Zollikofen, November 12, 2012
Page 1 of 10
Document 3032_2

Response to Request for Review - 6814 Busan Metro Line 1 Dadae

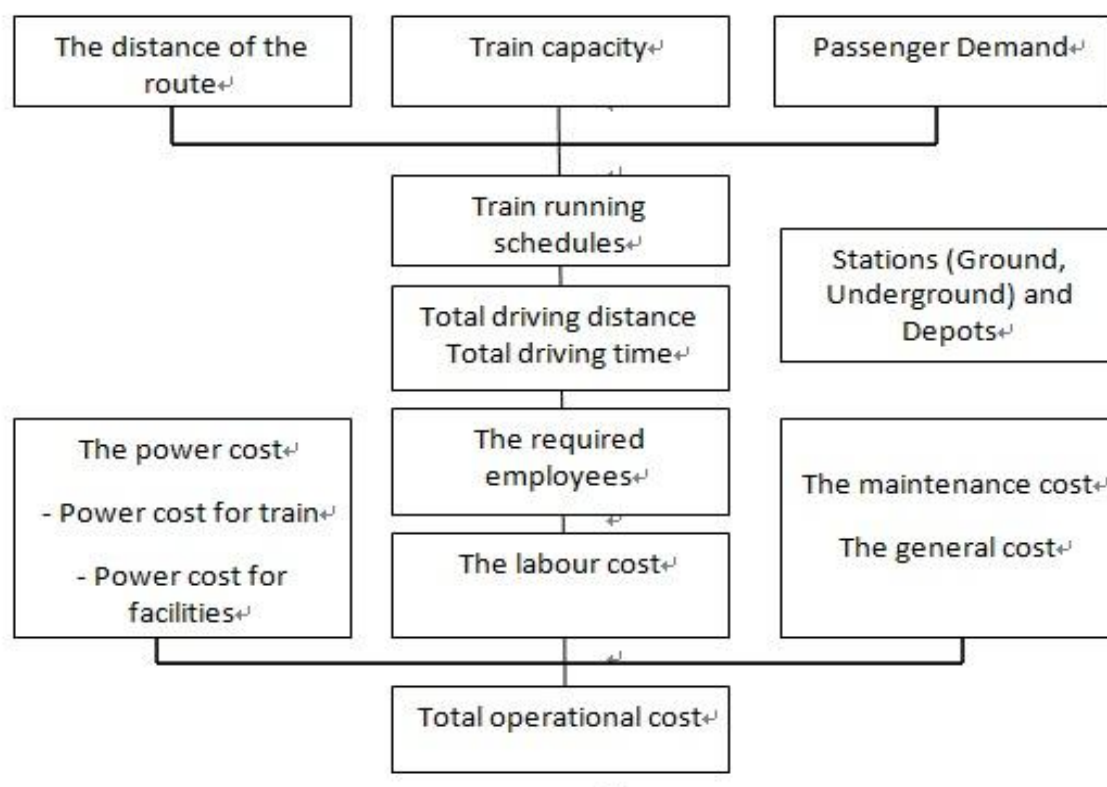
a) the total investment: how it has considered the range of 60-180 million USD for metro lines world wide (Bus-systems for the future, IEA, 2002) and 50-150 million USD/km mainly for European Metros in "another study" published in the year 2008 comparable, considering that: i) the project activity is an extension of an existing line, and ii) there are several metro projects in the host country and neighbouring countries;

The investment cost is based on Yusin Corporation, Chung Suk Engineering, an independent 3rd party. To assess the plausibility of the value independent and well-known international sources are taken, these being the IEA and a published report by B Flyvberg, Comparison of Capital Costs per Route-Kilometre in Urban Rail, EJTIR, 8, no. 1 (2008) which show that the investment cost of the project with 74 million USD/km (underground metro) is at the lower end of international estimates. The Article of Flyvberg includes thereby also the investment cost of Seoul metro network (117km), which is stated to be 65.8 million USD/km in 2002 (Table 3, p.23; this includes not only underground stretches; underground metro is more expensive than elevated or at-level, see IEA source). The most complete and comparable metro network in the same host country thus also indicates the plausibility of the used value.

Park and Han (2003) estimate the cost of building metros in Korea by 80-100 million USD/km (see cited in J. Pucher et.al., Public Transport Reforms in Seoul, p.56; The study for the state of construction and improvement policy of advanced transit system of Korea, 2003, in addition Annex 2: Public Transport Reforms in Seoul: Innovations Motivated by Funding Crisis, Journal of Public Transportation, Vol. 8, No. 5, 2005, SQS ref. [90])

The study for the state of construction and improvement policy of advanced transit system of Korea, 2003pdf, SQS ref. [90]) IEA for underground metros, Flyvberg, Seoul Metro and overall Korean metros thus all report values which are comparable to Busan. All of these data is based on independent reports and includes specifically Korean metros.
